# RENESAS TECHNICAL UPDATE

Product Category	MPU&MCU		Document No.	TN-380-A065B/E	Rev.	2.00
Title	Collected and revised edition of technical updates for 3803H/3804H groups flash memory version		Information Category	Technical Notification		
Applicable Product	3803 group (Spec. H) flash memory version M38039FFHSP/FP/HP/KP/WG 3804 group (Spec. H) flash memory version M38049FFHSP/FP/HP/KP 3803 group (Spec. L) flash memory version M38039FFLSP/HP/KP/WG 3804 group (Spec. L) flash memory version M38049FFLSP/HP/KP/WG	Lot No.	Reference Document	(Deleted in revision 2.00. No change in contents of technical update itself).

This document combines the following two technical updates for 3803H/3804H groups flash memory version and shows applicable products including 3803L/3804L groups. In addition, errors in the technical update (2) TN-380-035A/EA are corrected in this document.

2. Indeterminate value of ports during Power-on

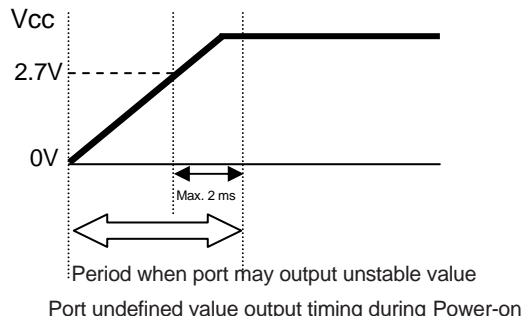
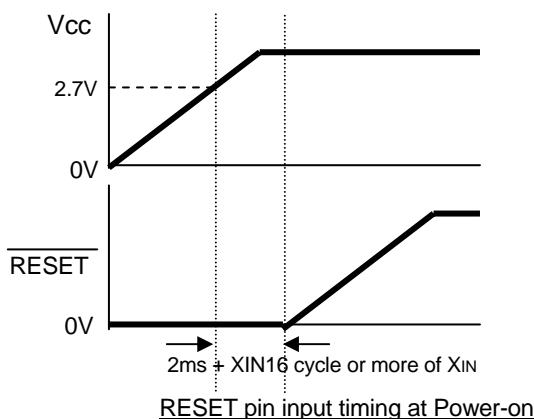
There might be cases that the MCU is not in a reset status until the internal power supply is stabilized (approximately 2ms). It prevents I/O ports from being in the input status, so that the I/O ports might output indeterminate value for a moment.

Revised version of M38039FFH (Spec.H-Flash) will be in mass-production around Aug, 2004.

1. Usage Notes

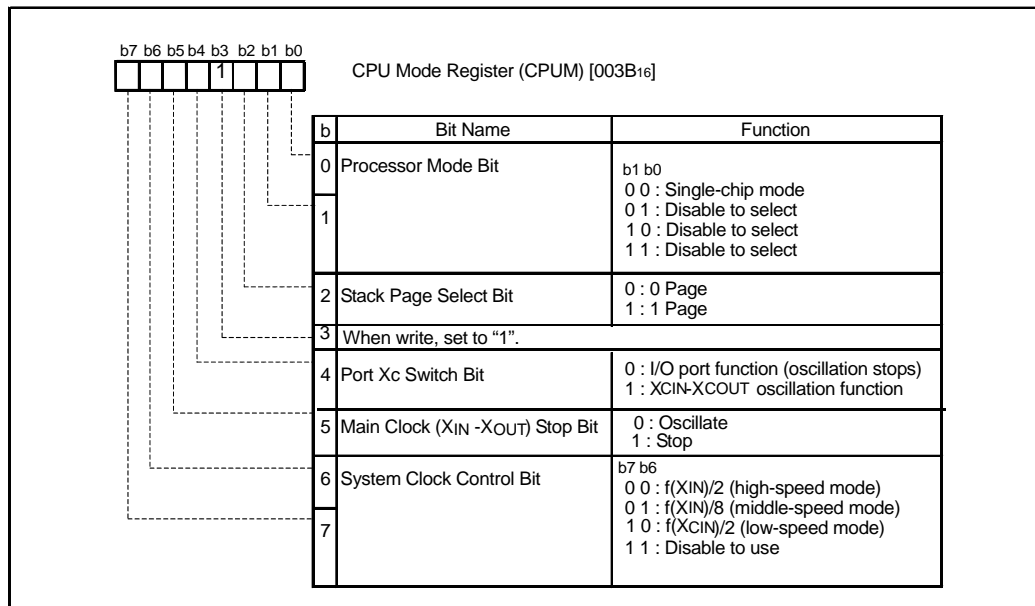
In the following cases, returning by an interrupt may not be performed.

- 1) When the main clock (XIN - XOUT) stops oscillating in low-speed mode and using wait mode.
- 2) When using stop mode in low-speed mode.
- 3) When using both (1) and (2).
